ADDENDUM #2

Date: May 25, 2020

PACIFIC REGION
PORT HARDY LOGISTICS DEPOT
PORT HARDY, B.C.
Project No: 8H500

McALLISTER MARINE SURVEY & DESIGN LTD.		TITLE TOWING BRIDLE CONNECTION	
		PROJECT DFO FLOATS V 10.035	
		CLIENT VANCOUVER PILE DRIVING LTD.	
SCALE NTS		DATE MAR 14/10	
DRAWN BY MSM		DWG # 10.035/2

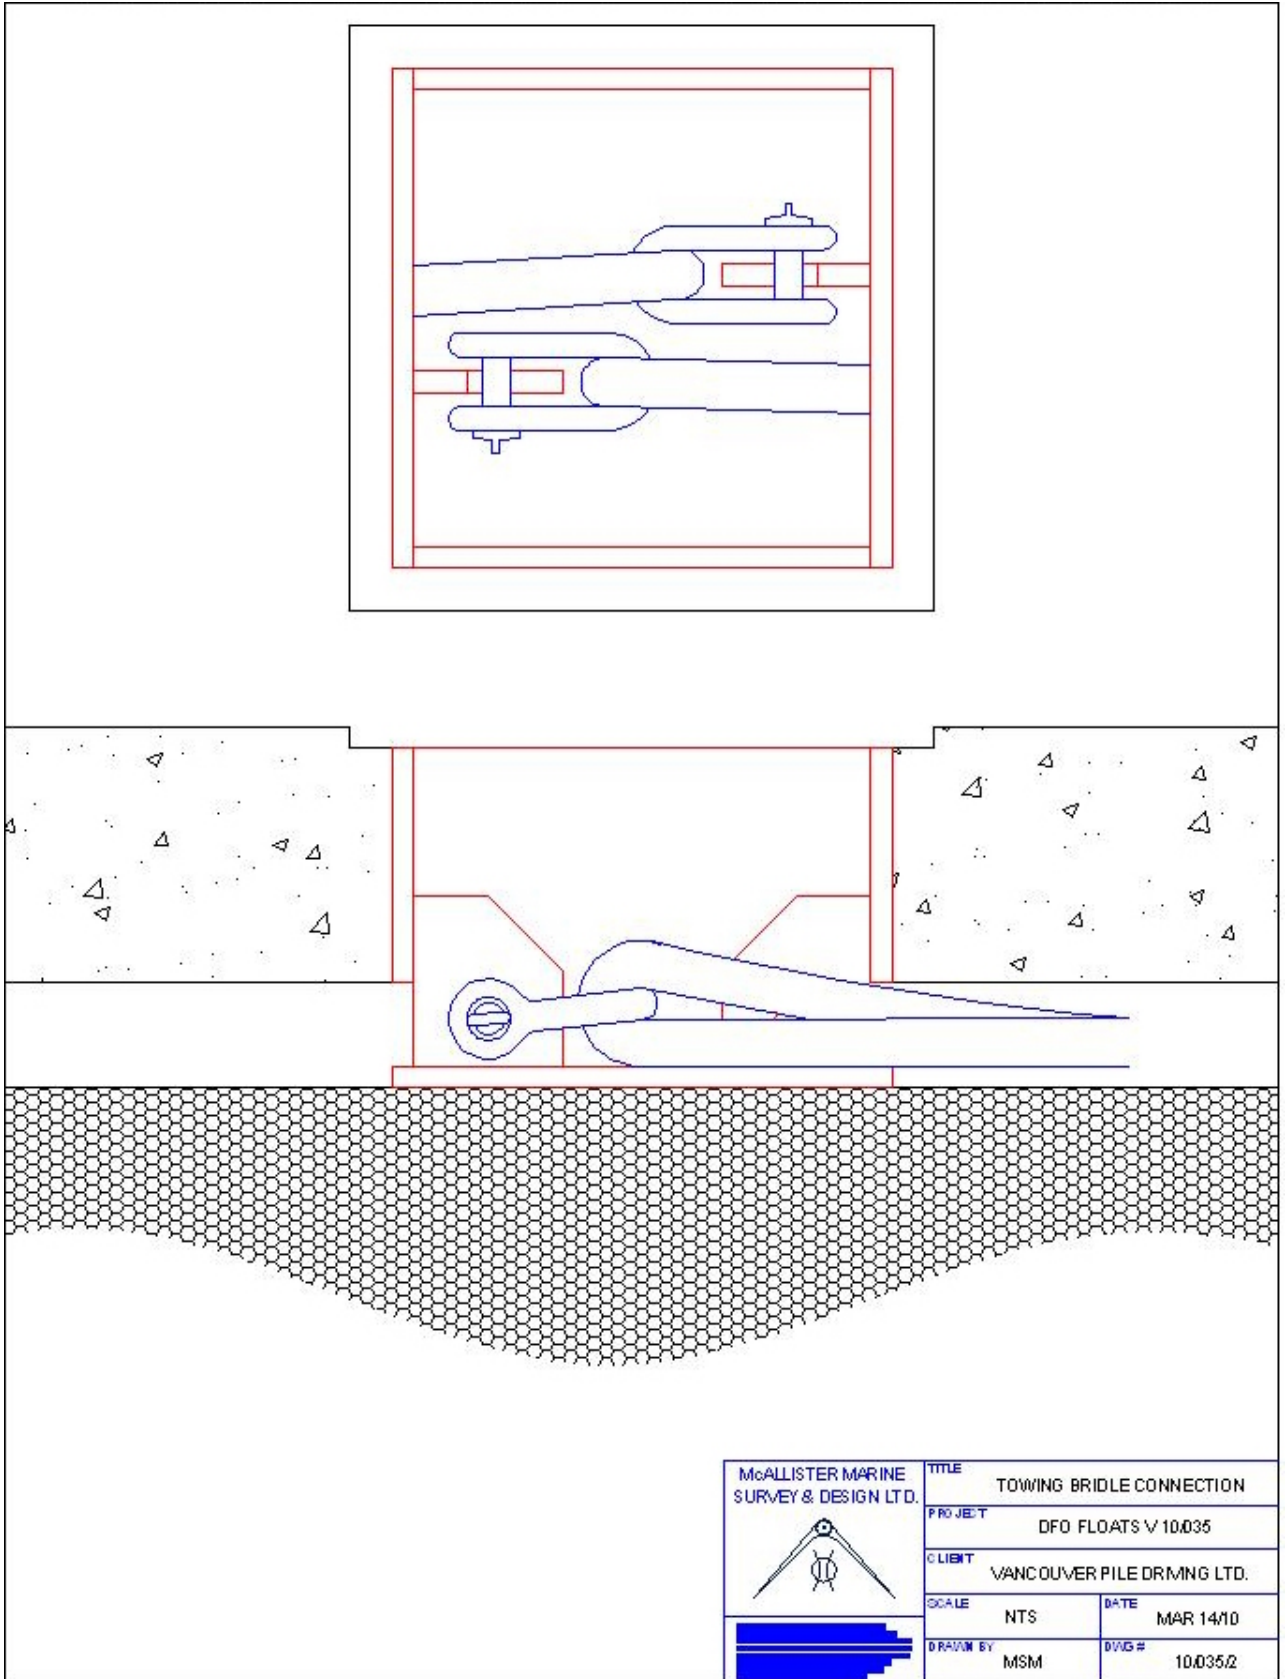
- 1) Towing connection is to be made to a weldment set into the centerline pocket at one end of each float. The weldments are to be altered from their previous configuration to provide connection points for 2 shackles as shown in the attached drawing. The towing bridle is to be led from the shackle connections through the pockets on the towing end of the float that are transversely outboard of the pocket with the connection.

- 3) Chafe protection is to be provided at the point of contact between the tow bridle and the forward end of the float. We understand that the proposed protection will consist of a temporarily installed pipe that will provide a round contact point for the bridle. This method of chafe protection is approved.

Mechanical Addendum #1
Revised Portion of:
HVAC Equipment Schedules M-05

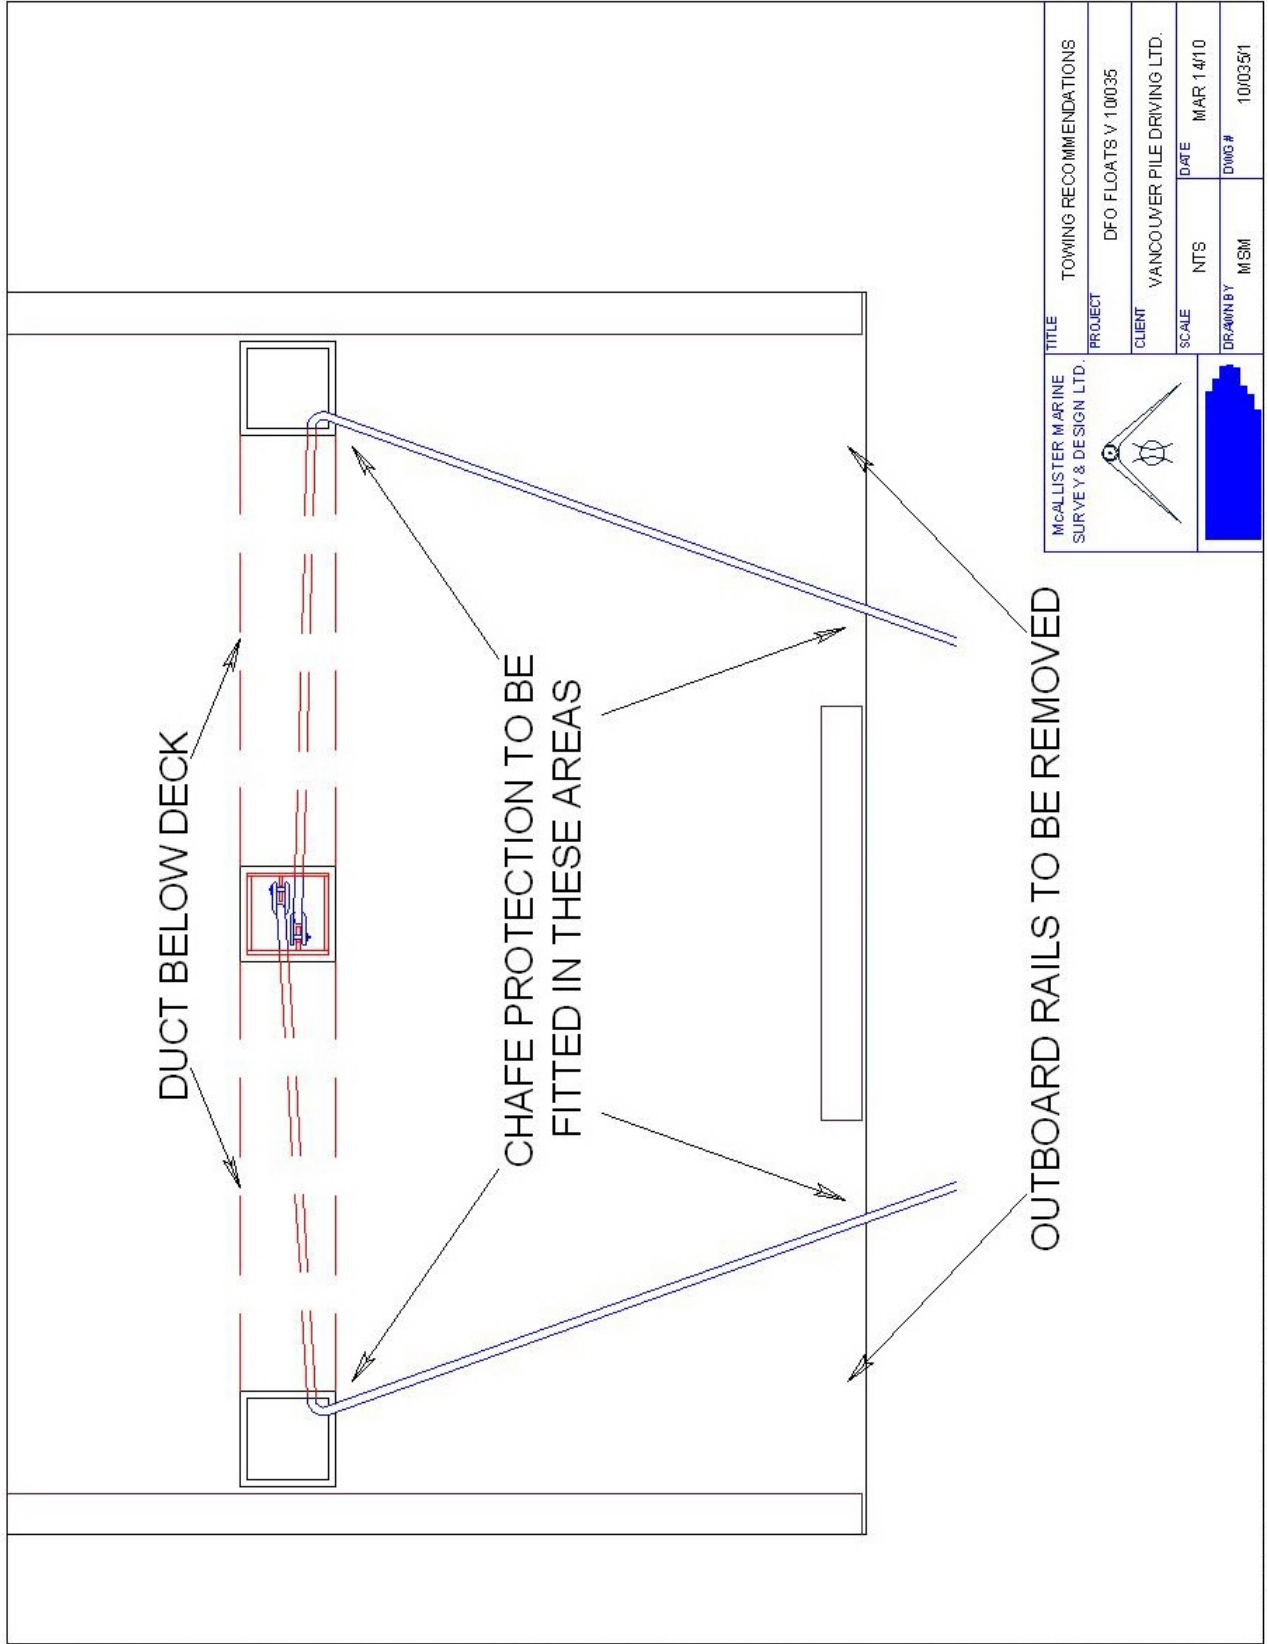
- Q.3 There are several issues with this Port Hardy Project.
- 1) Project design is not AWEF Compliant as of January 1, 2020
 - 2) I'll have to quote "New Compliant" Equipment to meet NRCAN Regulations not Legacy equipment as Specified.

- 3) NRCAN is no longer allowing equipment designed or built to contain HFC Refrigerants over 2200 GWP in Canada.(R22/R404/R507)
 - 4) July 10th is the deadline for Freezer equipment. NRCAN says any box designed to operate below 0°C/32°F is considered a freezer. If this is being installed before July 10 we can quote Legacy equip. but it will have to be with compliant refrigerant.(R44A/R449A)

- 5) The Cooler is a bit of a grey area showing an evap suction temp of 22°F which would mean that the cooler is a Freezer in the eyes of NRCAN because it will operate below 0°C / 32°F

- 6) NRCAN Describes Coolers as space operating above 0°C / 32°F this is right on the fringe. In this case an electric Defrost Coil should be used.
- A.3 See Mechanical Addendum #1

drawing **Canadian Coast Guard Proposed Jensen Cove Site Topographic Survey Over Lots 22 & 23, Plan VIP45348 Port Hardy, BC**

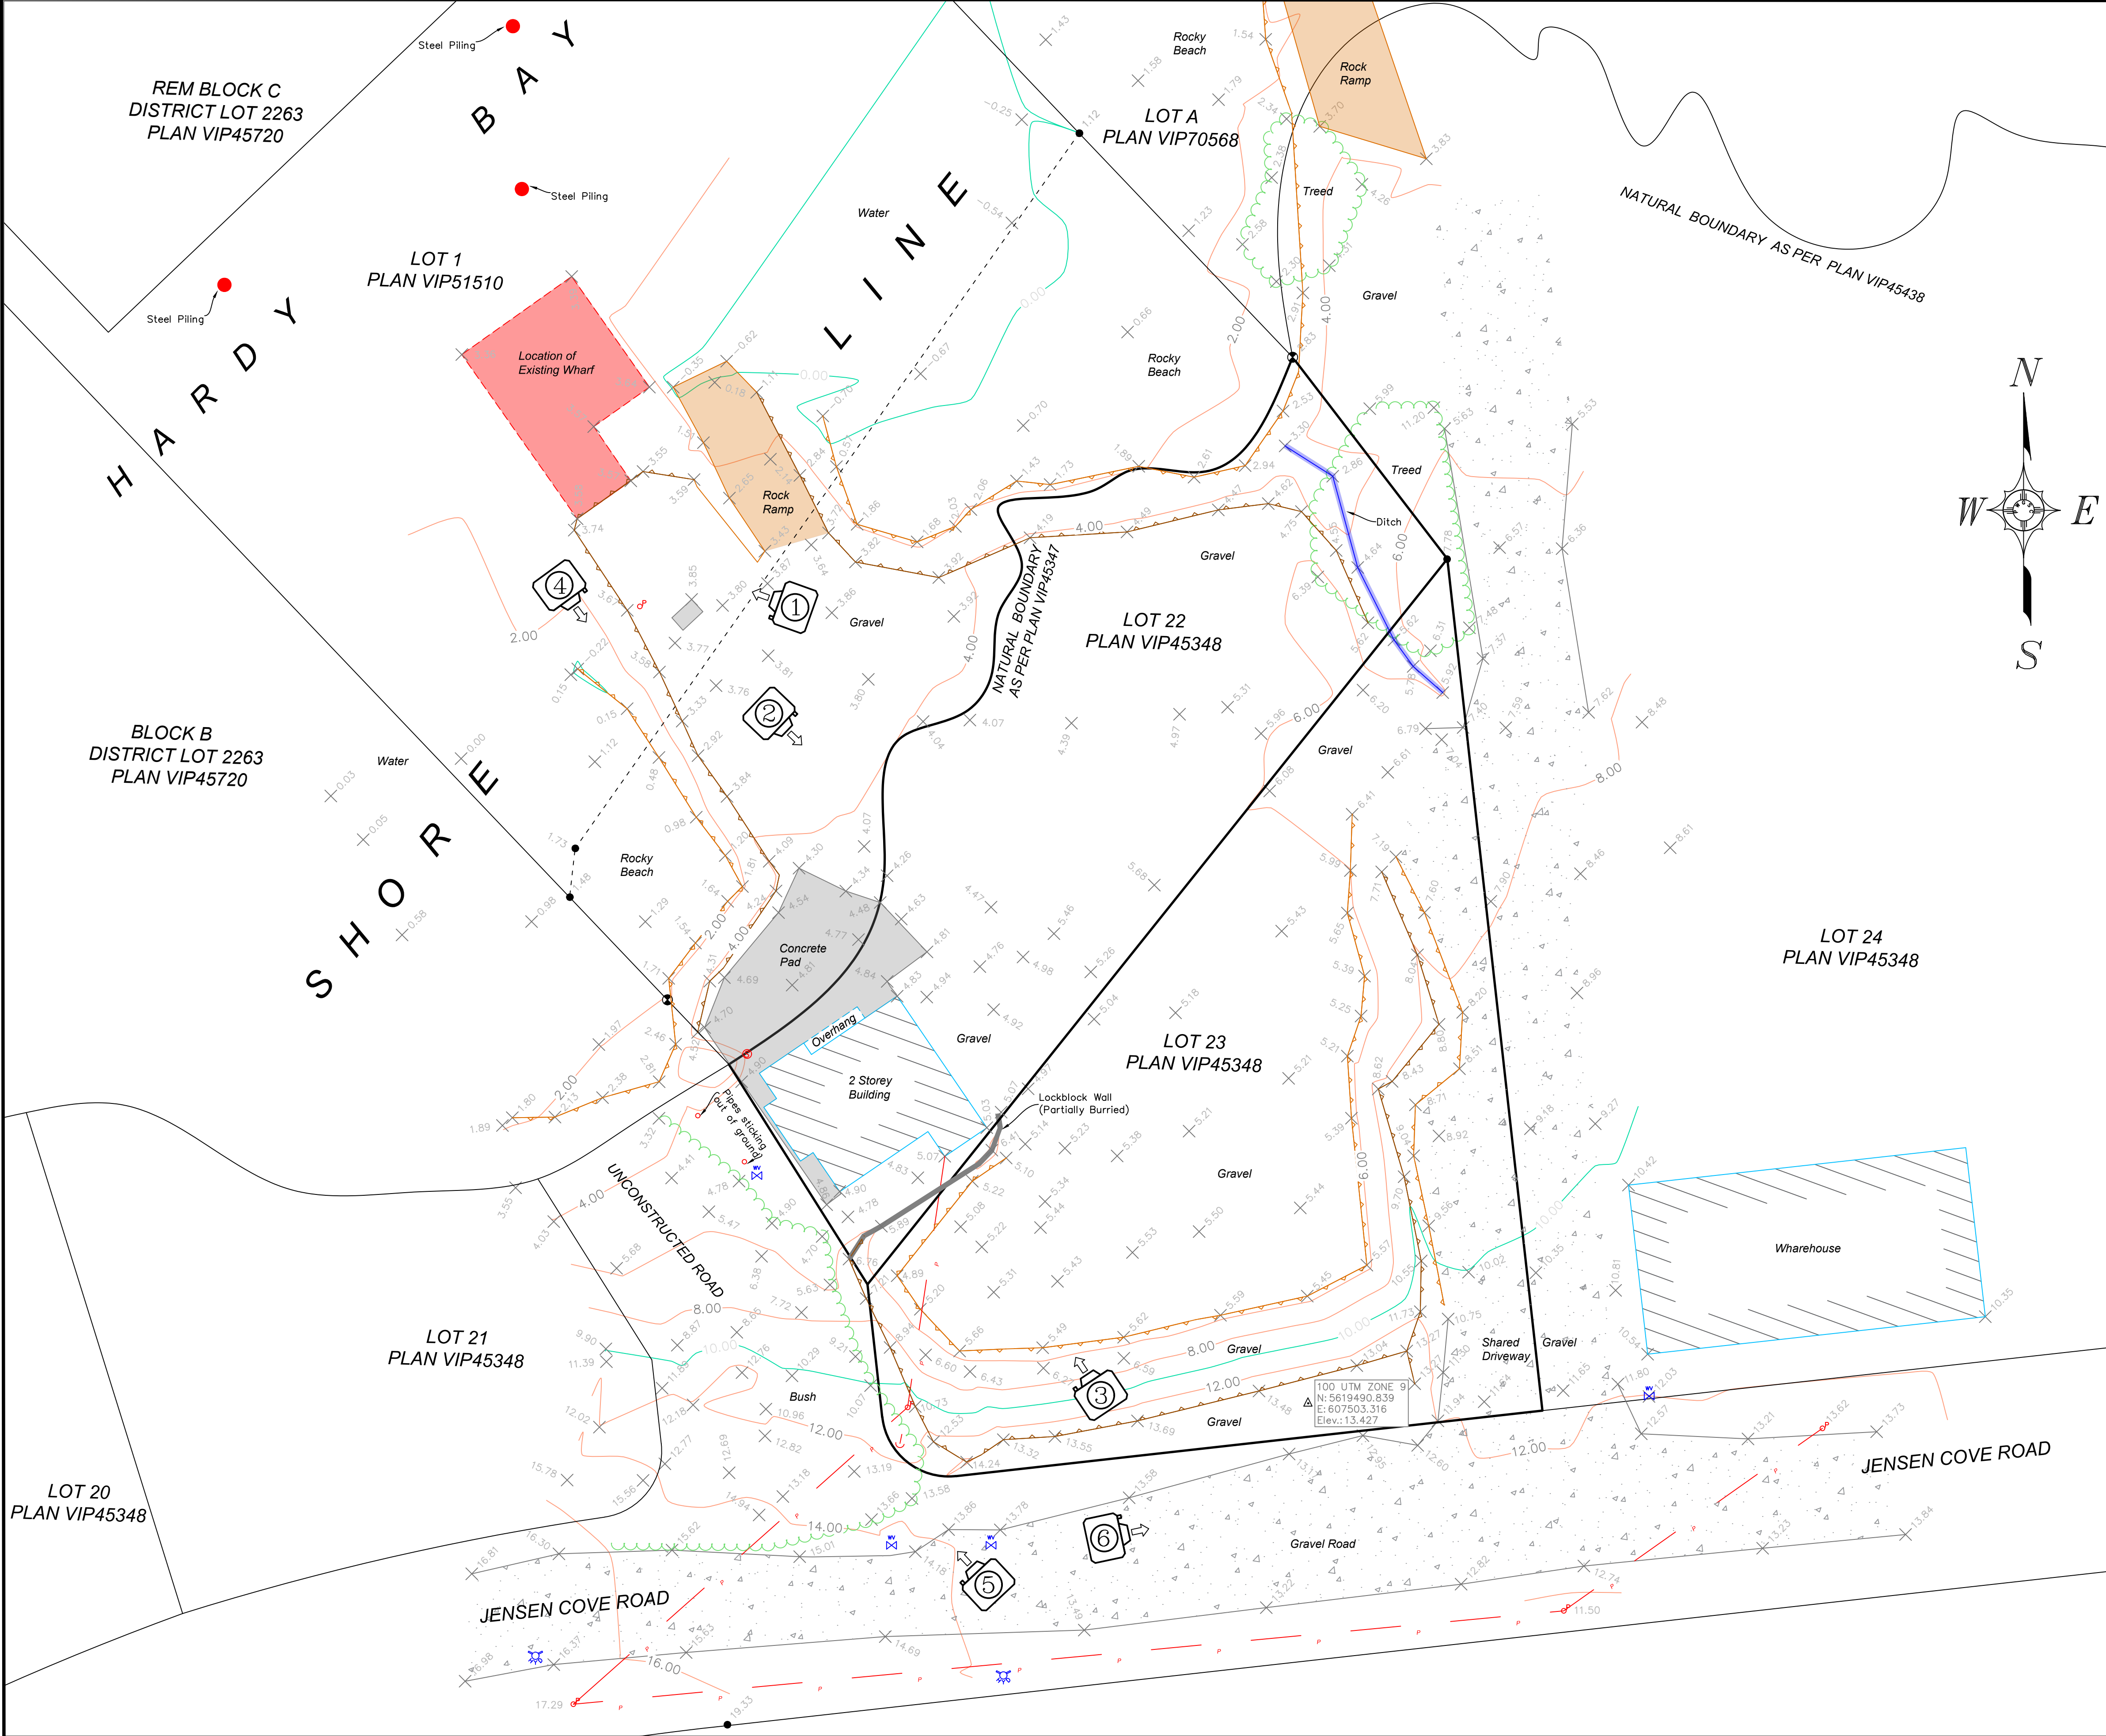
- Q.5 Please provide the existing topographical survey of the site as it is now. This is so we can work out the cut and fill to final grade.
- A.5 See drawing
"Canadian Coast Guard
Proposed Jensen Cove Site
Topographic Survey Over
Lots 22 & 23, Plan VIP45348
Port Hardy, BC"
Revised Feb. 25, 2019

Project No./No. du projet	Sheet/Feuille	Revision no./Lo Révision no.
1691-017	S201	2

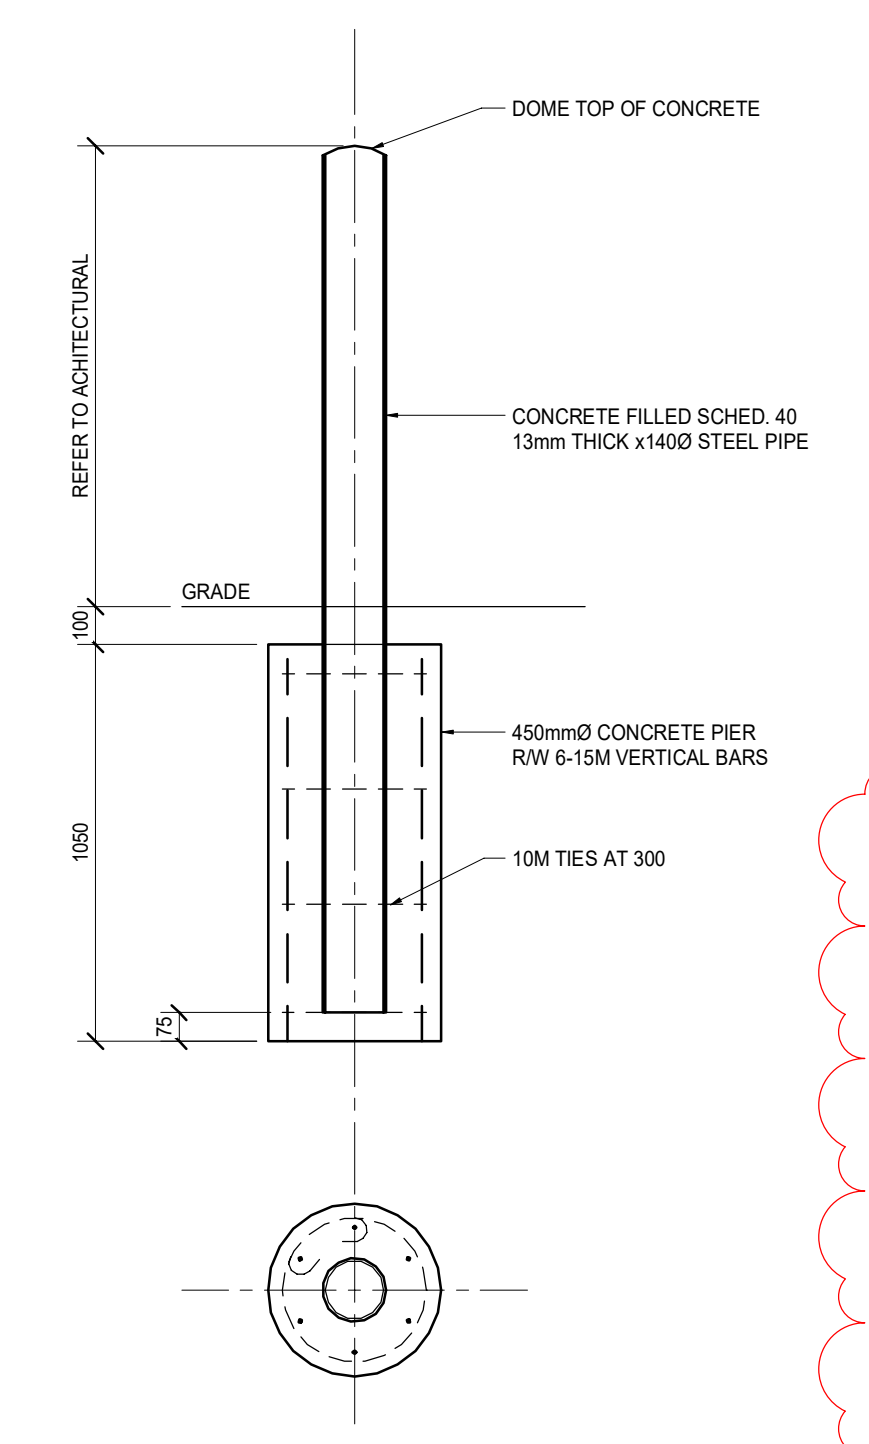
Q.10 Structural Drawing S201; Foundation Plan - Control joints are indicated in the 150mm thick SOG but not to the 125mm thick SOG – Are we to assume control joints are not required in 125mm Thick SOG?

A.10 See updated control joints in Structural Addendum #1

- Added a typical detail for flag pole bases on S102
- Added control joints to the slab-on-grade in the office area on S201
